ADDENDUM NO. 2

Date: May 23, 2022

Issued by: Sacramento City Unified School District

Project: Site Improvements – Genevieve Didion Elementary School

AS0.1

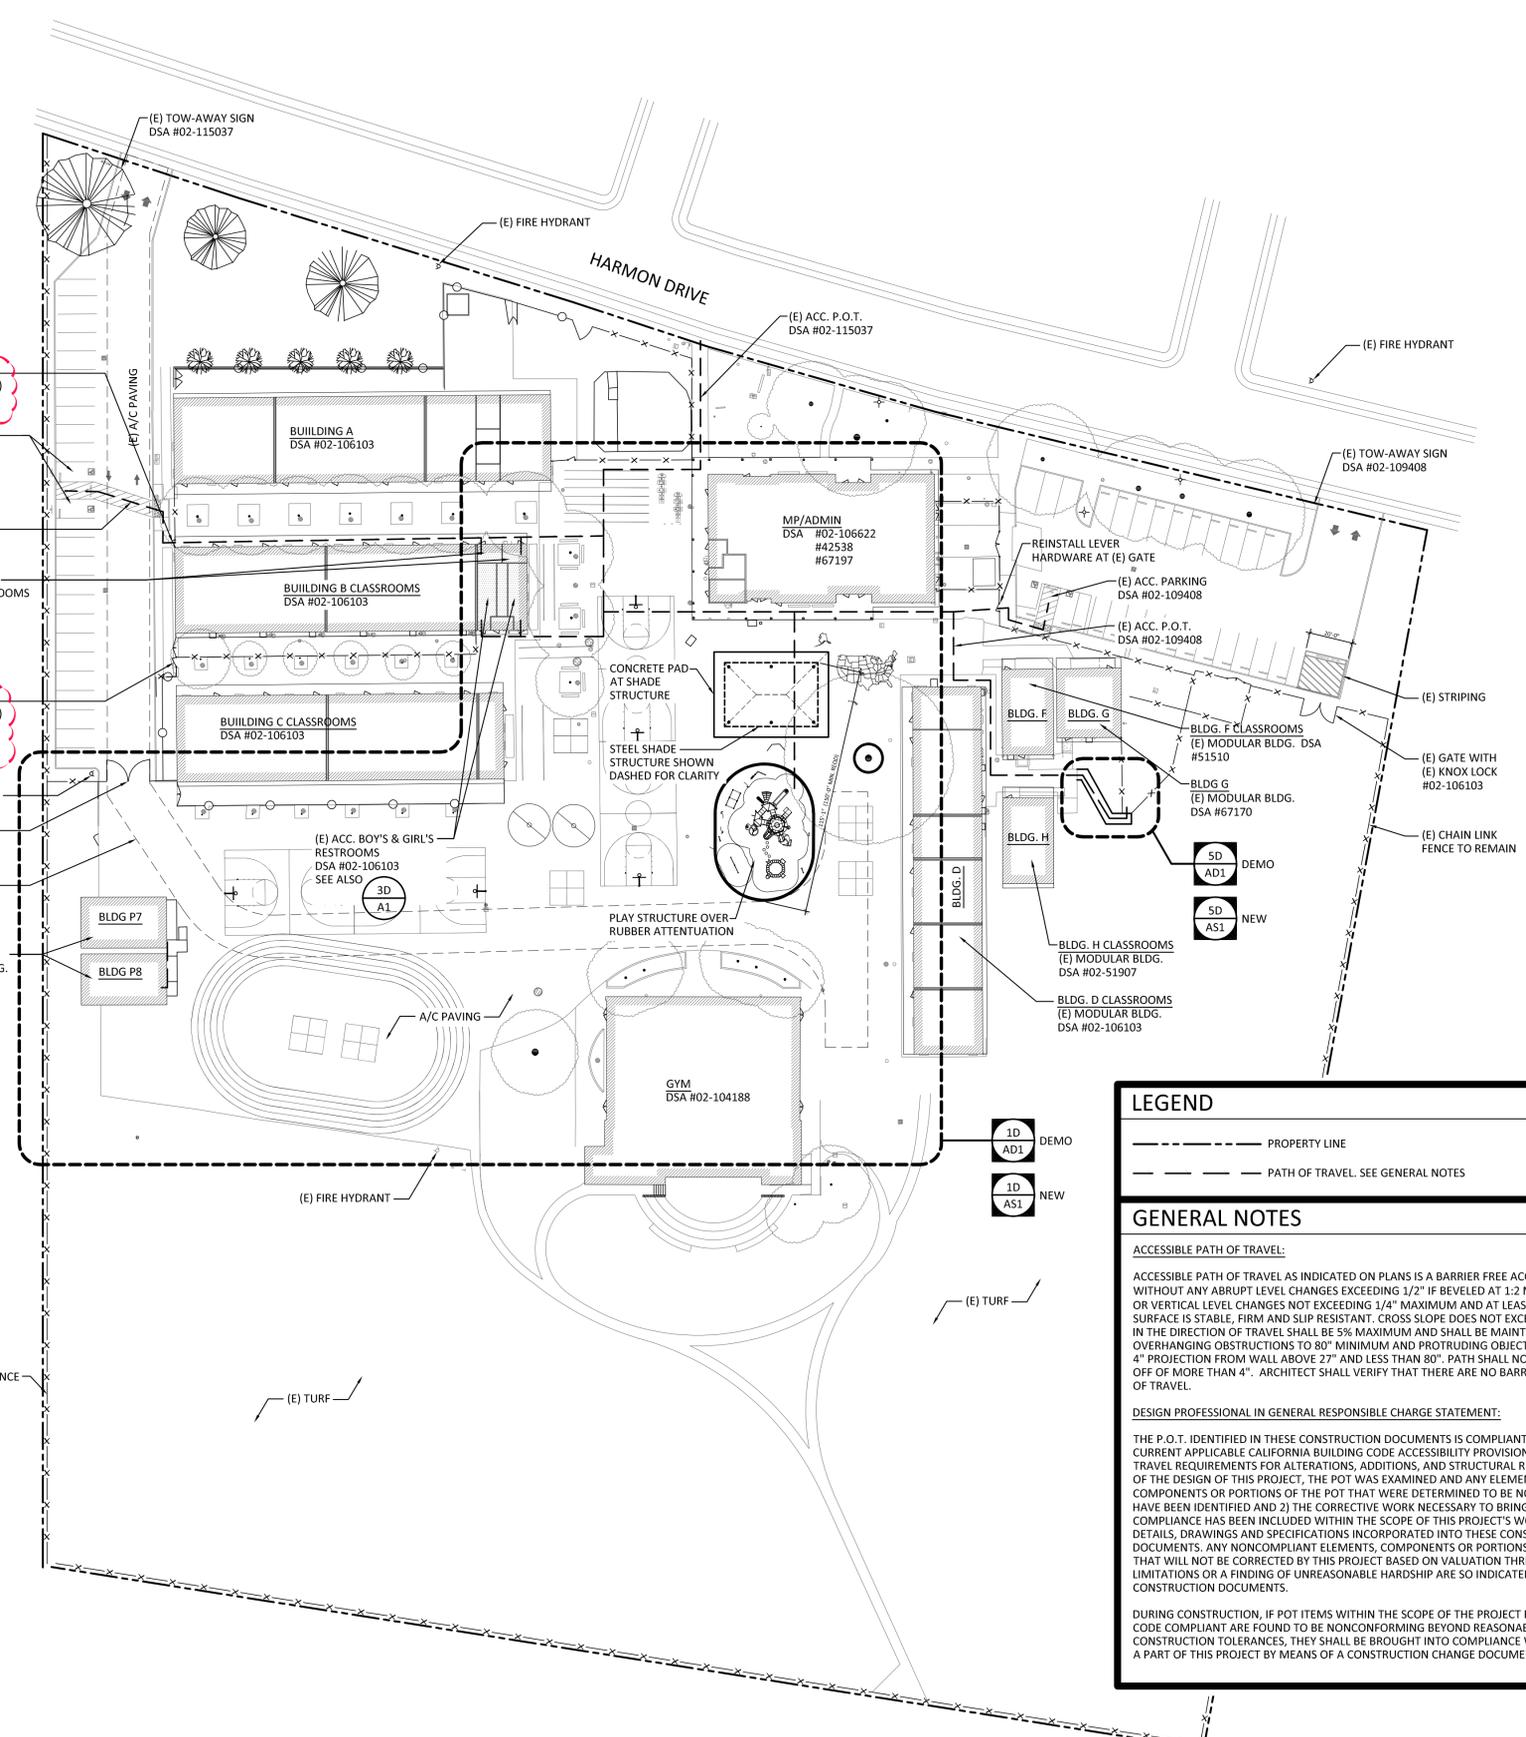
- 1 The Scope of Work has been clarified on sheet A0. The shade structure is Owner Furnished Contractor Installed (OFCI). The play equipment and rubber attenuation is Owner Furnished Owner Installed (OFOI).
- 2 Reinstall panic hardware – Von Duprin CD99 – at two existing gates on west side of campus. See sheet AS0.1.
- 3 Remove existing concrete benches on east side of hard court. See sheet AD1.
- 4 Demolish and replace existing a/c paving at southeast corner of hardcourt. See sheets C1.1, C1.2, C2.1, C2.2, AD1, and A1.
- 5 Remove and replace underground utilities. See sheets C1.1, C1.1-ALT, C2.1, C2.1-ALT, C2.2, and C4.1.
- 6 Striping plans have been revised. See sheet C3.1 and C4.1.
- 7 The rubber attenuation thickness varies. The maximum is 4.5” deep. The minimum is 3” deep. Provide a minimum of 4 inches of aggregate. See Play Systems sheet.
